CITY OF ALBUQUERQUE

Re: Martinez Retail Center
1021 Old Coors Dr SW
Traffic Circulation Layout
Engineer's/Architect's Stamp XX-XX-XX (L11-D071)

Based upon the information provided in your submittal received 08-08-23, the above referenced plan cannot be approved for Building Permit until the following comments are addressed:

TRAFFIC CIRCULATION LAYOUT PLAN

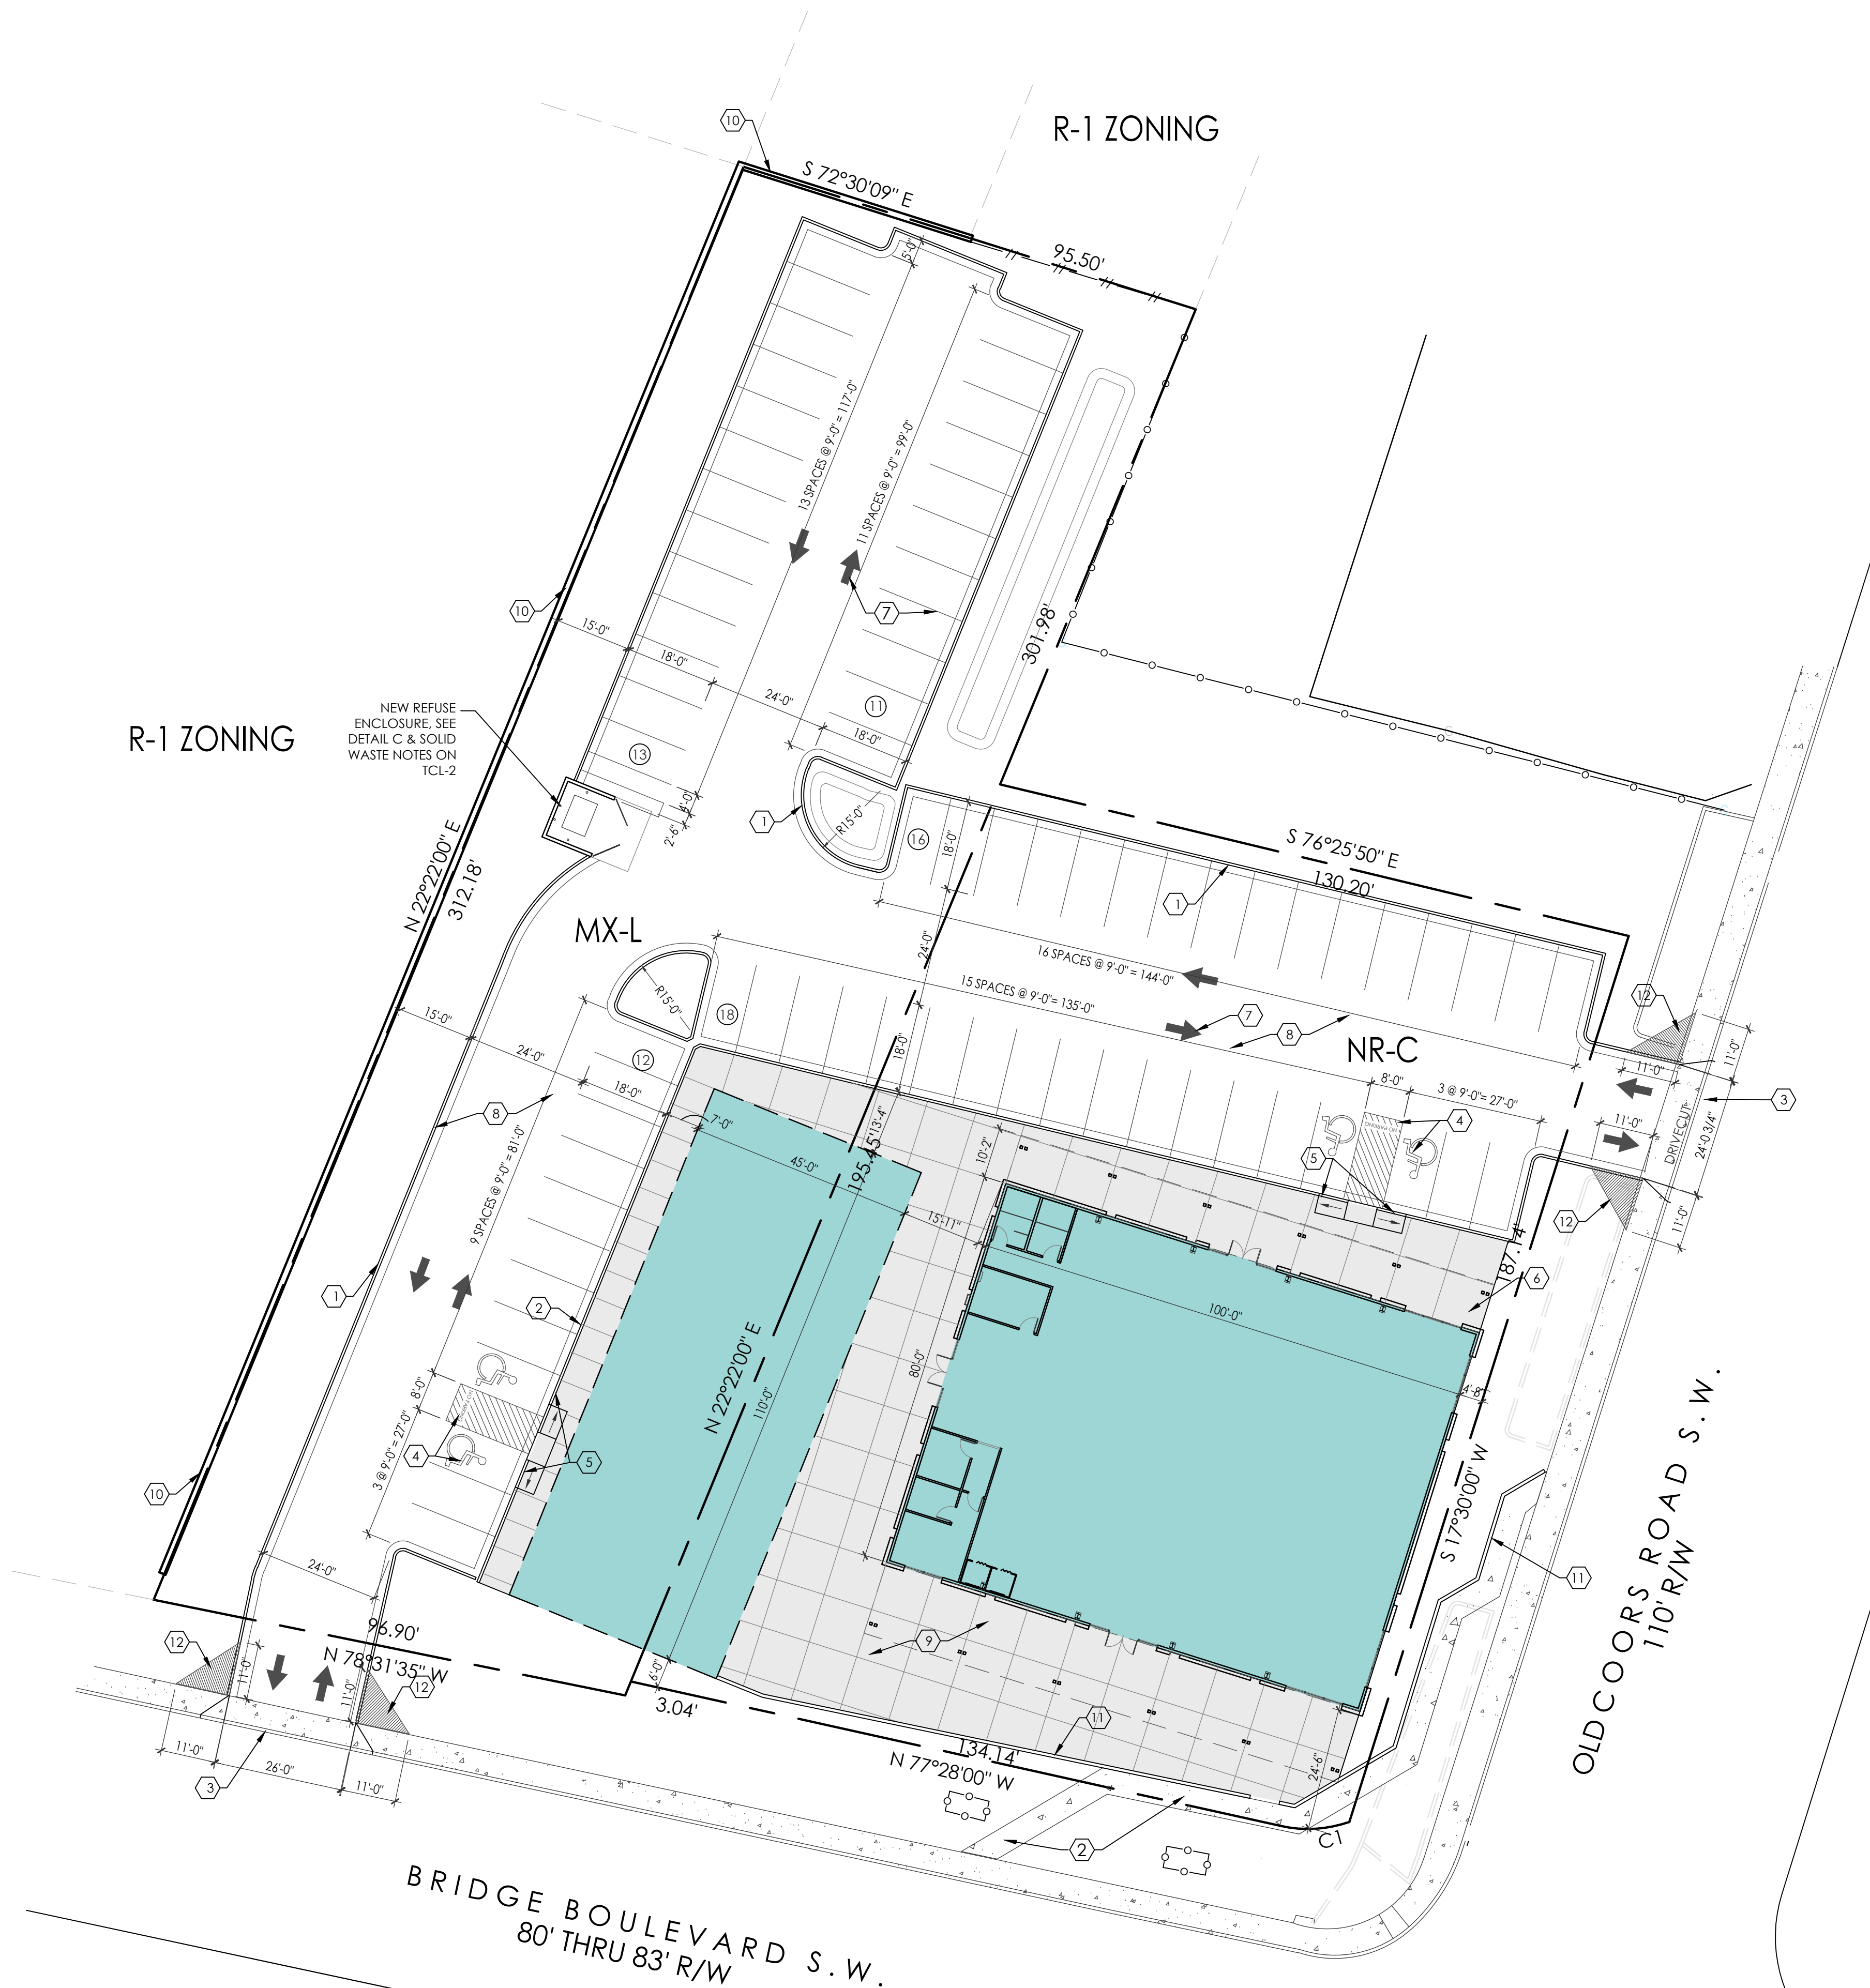
1. List the number of Motorcycle and Bicycle parking spaces required by the IDO.
2. Identify all existing access easements and rights of way width dimensions.

3. Clarify existing property lines and proposed property lines.
4. It appears there is a property line in the middle of the site plan, are you going to replat? Please address this concern.

5. Site accesses:
 - Per the DPM, Curb Returns rather than Drivepads are recommended on Arterials.
 - Per the DPM, A 50 ft. access throat length is required.

- 200 ft. is the minimum required distance from commercial site access points to the intersection. Please show this dimension on the site plan.
 - Are you going to close the existing drivepad off Old Coors? Due to the existing manhole, please contact Water Authority department (jshell@abqwua.org).

6. Keynote 2: please provide pedestrian pathway details (length, width, cross slope and running slope).
7. Provide details for the proposed interior ADA ramps.

8. The pavement marking "MC" should be shown in the opposite direction for motorcycles entering the parking space.
9. Per DPM, a 6 ft. wide ADA accessible pedestrian pathway is required from the ADA parking stall access aisles to the building entrances. Please clearly show this pathway and provide details.

10. ADA accessible pedestrian pathway should not be placed behind parking space or adjacent to a vehicular way. Vehicle and pedestrian/wheel chair conflicts should be avoided as much as possible.

14. Unused curb cuts must be replaced with sidewalk and curb & gutter. A build note must be provided referring to the appropriate City Standard drawing.
